Work Order ID 86982

Item Name: Crosstube Fwd

DART AEROSPACE LTD		Work Order:	86982
Description: Crosstube High Fwd (205/212/412)		Part Number:	D212-664-101
Inspection Dwg: D212-664-141		Rev: D	Page 1 of 1

DRAWING NO. D212-664-141	TITLE XTUBE ASSY (205/212/412 HI FWD)	REV. D	DART AEROSPACE LTD ENGINEERING ORDER		D.E.O. NO. D212-664-141-D-1	SHEET NO. SHEET 1 OF 2	SCALE NTS
DRAWN	CHECKED	MFG. APPR.	APPROVED	DE APPR.			
DATE 11.04.07	DATE 11.07.11	DATE 11.04.12	DATE 11/09/12	DATE 11.04.12

**D212-664-141/-141B
ASSEMBLY DETAIL**

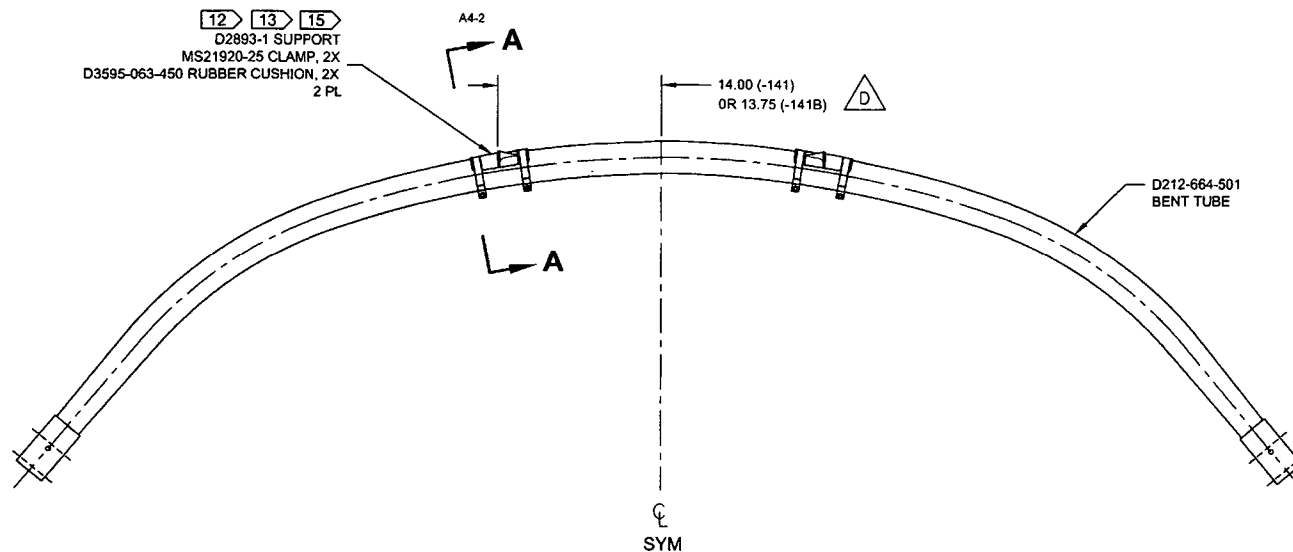
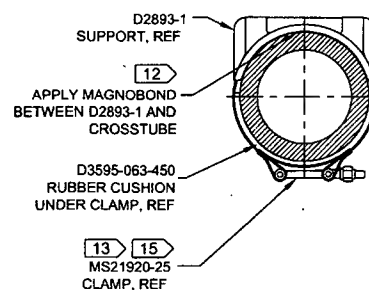
REPLACE MAGNOBOND WITH PROSEAL.

NOTE 12 & 15, SHEET 1 IS AMENDED AS FOLLOWS:

Item	Qty -141	Qty -141B	Part Number	Description
7	A/R	A/R	PROSEAL 890 B-2	SEALANT, AMS-S-8802 CLASS B-2

- 12) TO INSTALL D2893-1 SUPPORT: ABRASE MATING SURFACE OF SUPPORT AND CROSSTUBE WITH 180-GRIT SANDPAPER AND REMOVE RESIDUE WITH MEK (OR EQUIVALENT). APPLY A 0.04" TO 0.07" THICK LAYER OF PROSEAL 890 CLASS B-2 (OR AMS-S-8802 CLASS B-2) SEALANT TO MATING SURFACE OF SUPPORT.
- 15) TORQUE CLAMPS 80 TO 100 IN-LB. ENSURE AT LEAST 1.5 THREADS SHOWING IN SAFETY AND THAT NUT HAS NOT BOTTOMED-OUT AFTER TORQUING. **PRIOR TO PACKAGING, RE-CHECK TORQUE ON CLAMPS AFTER PROSEAL 890 SEALANT HAS CURED FOR 72 HOURS.**

**D212-664-141/-141B
ASSEMBLY DETAIL**

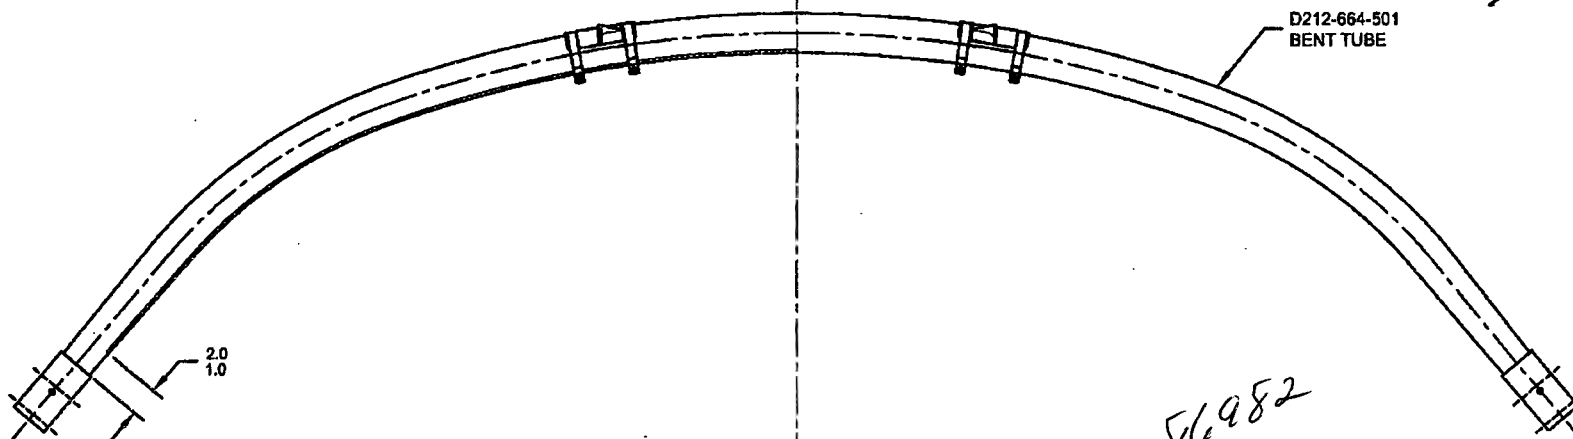
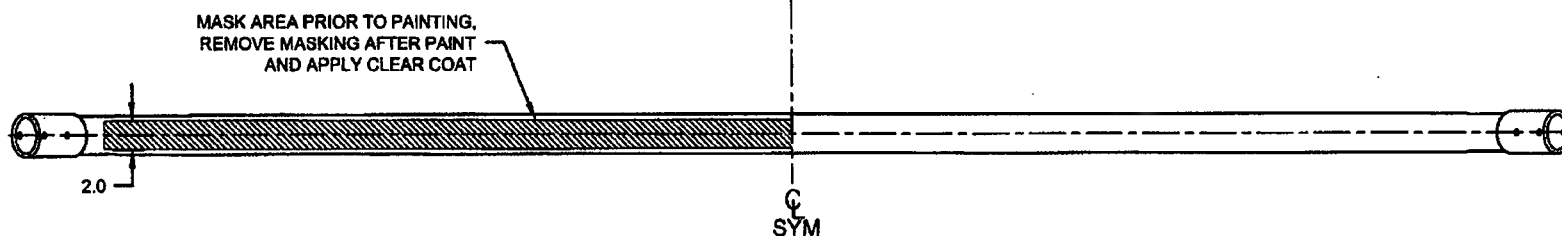
PURPOSE:

ADD AN INSPECTION WINDOW TO UNDERSIDE OF CROSSTUBE.

NOTES 2 OF SHEET 1 IS AMENDED AS FOLLOWS:

- 2) FINISH: CHEMICAL CONVERSION COAT PER DART QSI 005 4.1
PRIME INSIDE AND OUTSIDE PER DART QSI 005 4.2
MASK UNDERSIDE OF CROSSTUBE AS SHOWN (HATCHED AREA) AND
PAINT OUTSIDE PER DART QSI 005 4.2
REMOVE MASKING AND APPLY CLEAR COAT

- 2) FINISH: CHEMICAL CONVERSION COAT PER DART QSI 005 4.1
PRIME INSIDE AND OUTSIDE PER DART QSI 005 4.2
PAINT OUTSIDE PER DART QSI 005 4.2
